### Section III (Remarks)

#### Objection to the Drawings Under 37 C.F.R. 1.83 (a)

In the December 10, 2004 Office Action, the Examiner objected to the originally filed drawings of the application as allegedly lacking features specified in the claims. Specifically, the Examiner identified the timer as claimed in claims 8, 12, 13 and 42 and the pumper cabinet as recited in claims 23 and 52 as having to be shown, or such features cancelled from the claims.

**FIG. 12**

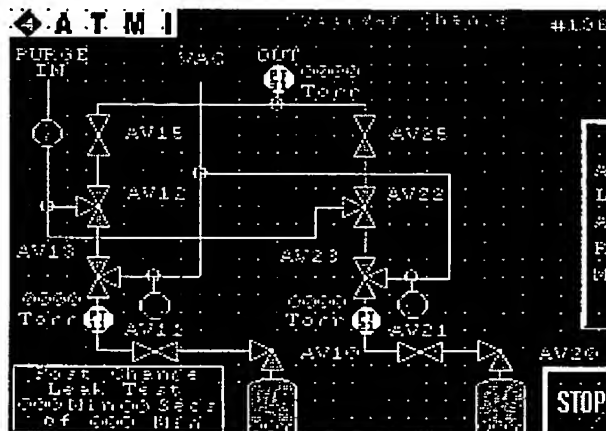
The Examiner's attention is also directed to originally filed FIG. 12, which is reproduced below for ease of reference, as showing a timer in the lower left-hand portion of the screen.

The timer indicates elapsed time ("000 Min 00 Secs of 000 Min") of the Post Change Leak Test.

The foregoing clearly provides sufficient basis in the drawings for the recital of a timer in claims 8, 12, 13 and 42.

**FIG. 14**

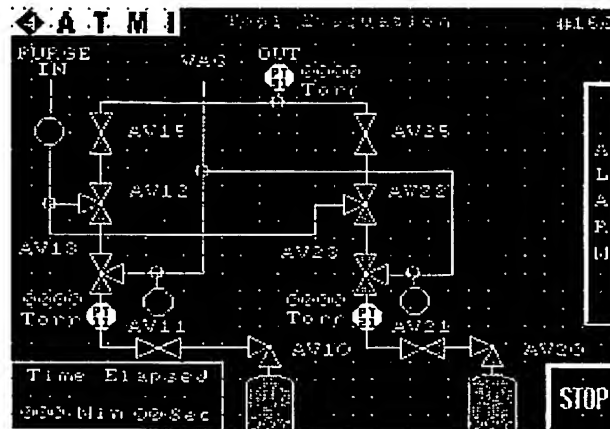
See also originally filed FIG. 14, which likewise shows the timer in the lower left-hand portion of the screen.

The timer shows "Time Elapsed" as "000 Min 00 Sec." Similar screens containing timers are shown in FIGS. 15 and 17.
